# VALUE ENGINEERING REPORT

**SR 400 / Northridge Road Interchange  
Fulton County  
NH000-0056-01(061), PI No. 751580**

November 8, 2011

SR 400 / Northridge Road Interchange  
Fulton County, Georgia  
State Project No. NH000-0056-01(061)

Idea No.: A-3  
Client: GDOT  
Sheet 2 of 4

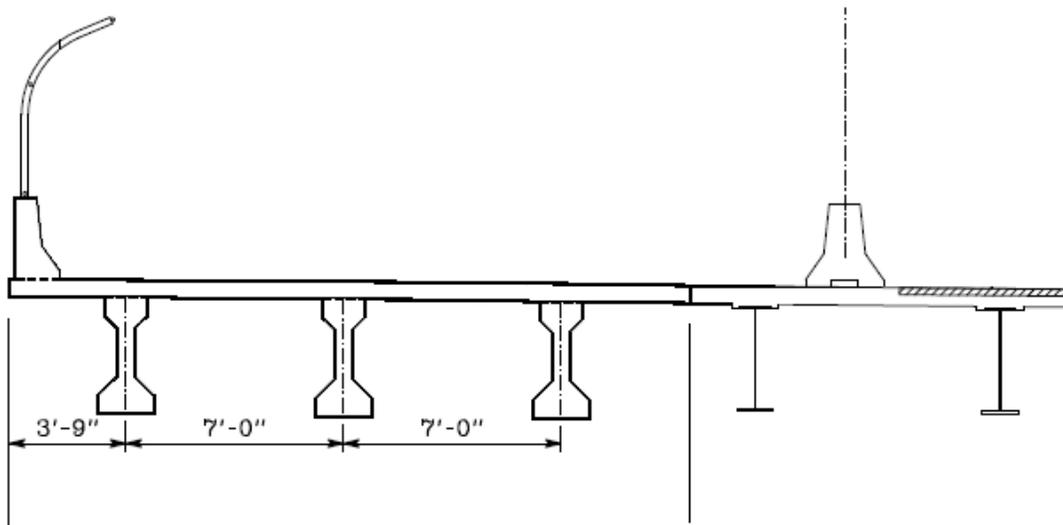
The current design for widening the existing Northridge Bridge uses steel beams (in-kind) to add an additional 22 feet of width to widen the through traffic lanes and accommodate a separate NB SR 400 to NB Dunwoody Place turn movement.

A design condition for this project is that improvements constructed in this contract should be assumed to be “short term” since the entire Interchange will be reconstructed to accommodate the future widening of SR 400. The main spans for the bridge are less than 100 feet long. Adequate vertical clearance exists on the north side of the bridge where the widening will take place to accommodate the Type 3 PSC beams. The use of Type 3 PSC beams is more economical than steel beams.

**Proposed Change:**

Idea No.: B-2  
Client: GDOT  
Sheet 2 of 4

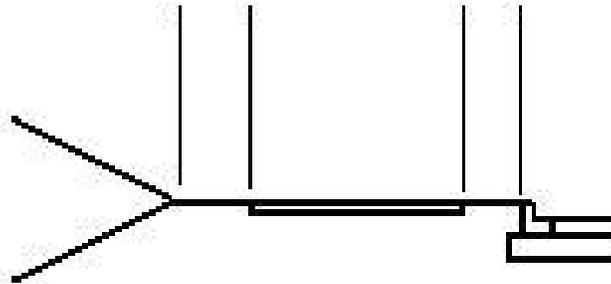
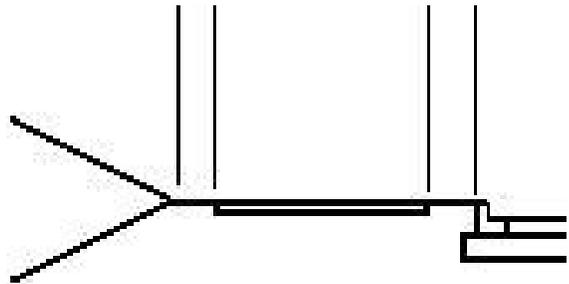
The purpose of the outside shoulder is to accommodate pedestrians on the sidewalk and provide a portion of the required roadway clear zone. The purpose can be accomplished with a 10-foot wide shoulder. Reducing the shoulder width will reduce the amount of R/W and permanent easement required to construct this project. This concept places the sidewalk 1.5 feet from the back of the curb and gutter and 1-foot from the shoulder break point.

The revised concept proposes to install a 10-foot wide outside shoulder from Station 204+90 Left to Station 210+16 Left on Northridge Road.

Idea No.: G-5  
Client: GDOT  
Sheet 2 of 4

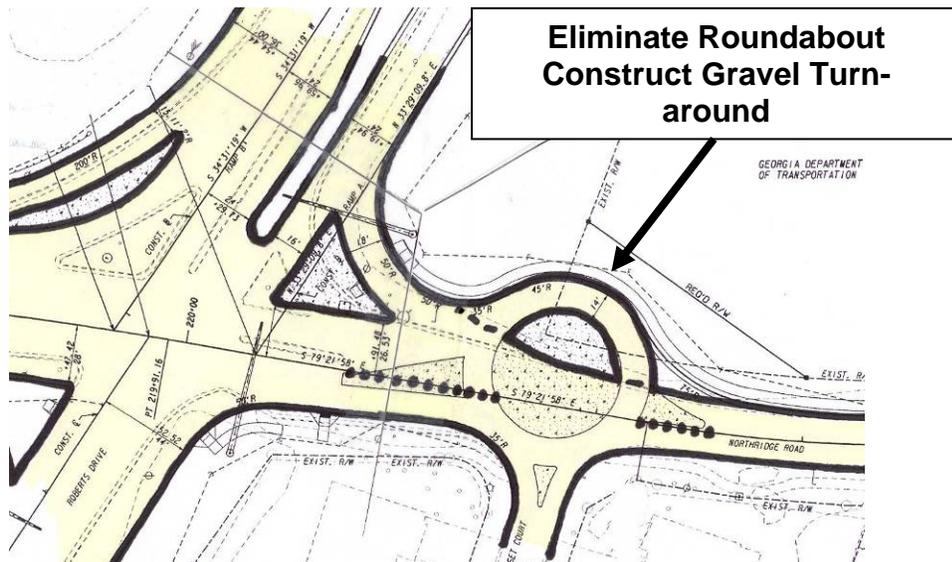
Due to the extensive back-ups and travelers trying to by-pass the NB SR 400 left turn, the residents on Somerset Court complain of U-turns on their road. The overall traffic improvements and double left turn lane proposed will help in alleviating the traffic backups for this movement. The proposed roundabout will actually entice drivers to use this location for an unwarranted U-turn however. Constructing a driveway opening with only a gravel driveway will allow for a U-turn for the lost driver but will not entice drivers to by-pass the signal.

**Proposed Change:**

Idea No.: G-5.1  
Client: GDOT  
Sheet 2 of 4

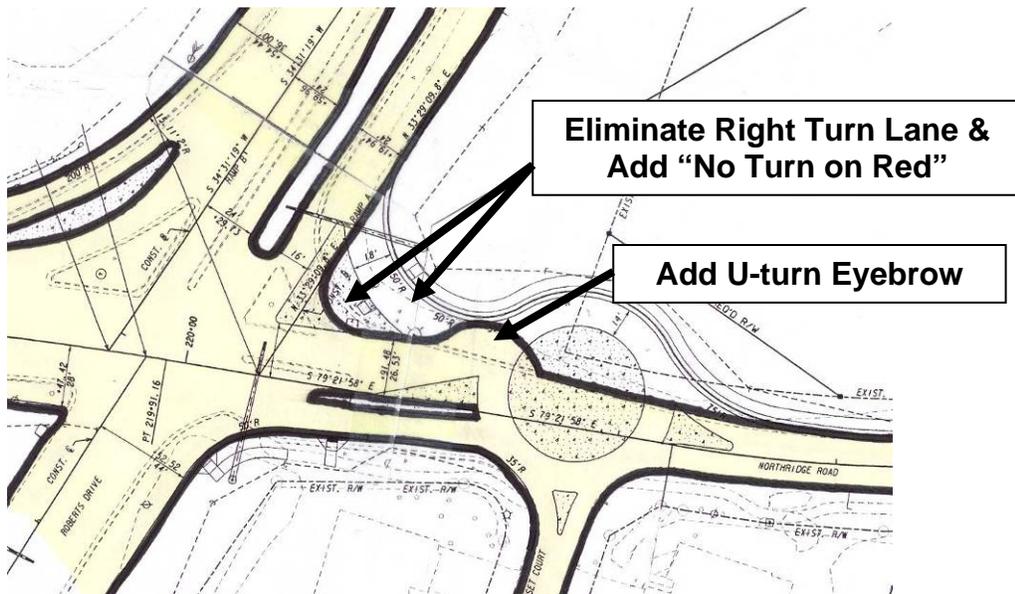
This concept provides a U-turn Eyebrow area for eastbound vehicles to make a U-turn without entering the Somerset Court Subdivision. This concept also eliminates the direct right turn connection (DHV of 5) to the SR 400 NB On-ramp and prohibits “right turns on red” at the Northridge Road / Roberts Drive intersection. This concept will discourage vehicles wanting to use this intersection to “bypass” the eastbound Northridge Road to NB SR 400 On-ramp left turn movement at the Roberts Road intersection.

**Proposed Change:**

**Northridge Road / NB SR 400 Intersection**

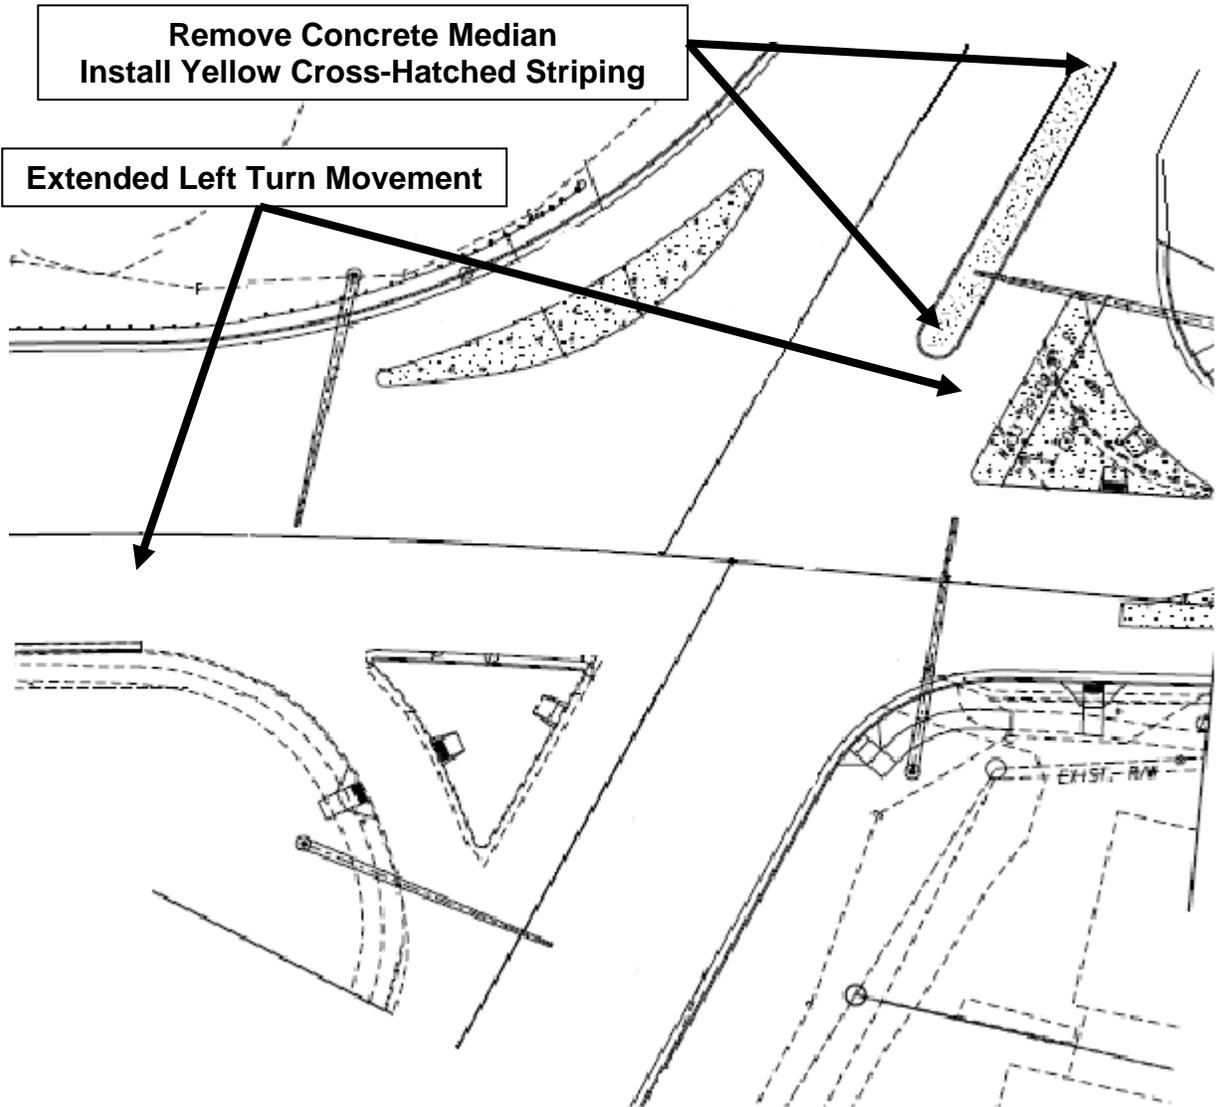
The purpose of the median area is to separate traffic using the SR 400 entrance and exit ramps. This purpose can be accomplished by the use of yellow cross-hatch striping. Because of the large skew angle and multi-lane exit ramps in both of the Northridge Road / SR 400 ramp intersections, the Northridge Road left turn movement into these entrance ramps will be very wide (over 100 feet).

Separating the ramps with a yellow cross-hatch striped median provides a visual barrier that motorists will recognize and stay to the right. It will also allow for the opportunity to correct a possible wrong-way movement situation. This item has a potential cost increase because the striped median area will have to be constructed with full-depth pavement.

This recommendation would eliminate the curb and gutter / concrete median paving and replace them with yellow cross-hatch striping.

Idea No.: H-2  
Client: GDOT  
Sheet 2 of 5

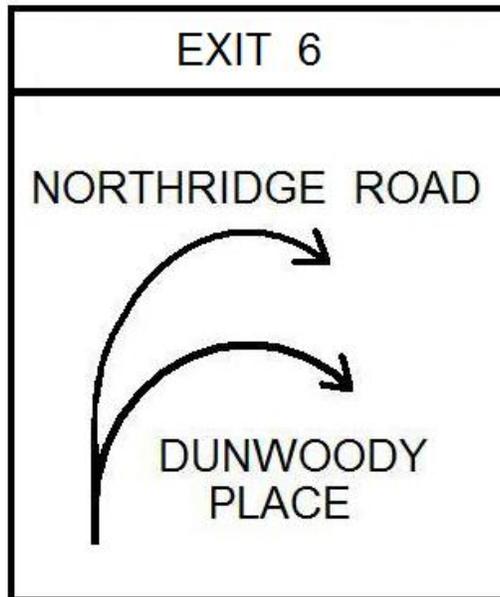
New and additional signs are needed to delineate the NB SR 400 dual-lane exit ramp for the separate NB SR 400 to NB Dunwoody Place designated lane and the separate NB SR 400 to Northridge Road exit lanes. The NB SR 400 exit ramp signs should show split destinations.

A large cantilever mounted sign should be placed as close to the exit gore as possible to direct the motorists to the correct lane. This idea will result in a cost increase to the project.

This recommendation would revise the exit signage for NB SR 400 Off Ramp.

Idea No.: H-4  
Client: GDOT  
Sheet 2 of 4

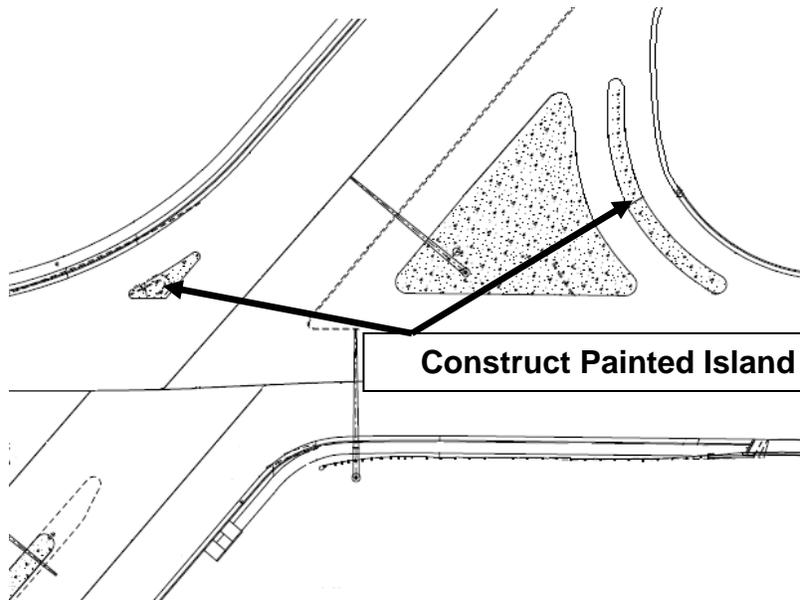
The purpose of the concrete islands is to channel and direct traffic to the appropriate lane. This purpose can be accomplished by utilizing white or yellow cross hatch striping. This concept will simplify and accelerate construction.

**Proposed Change:**
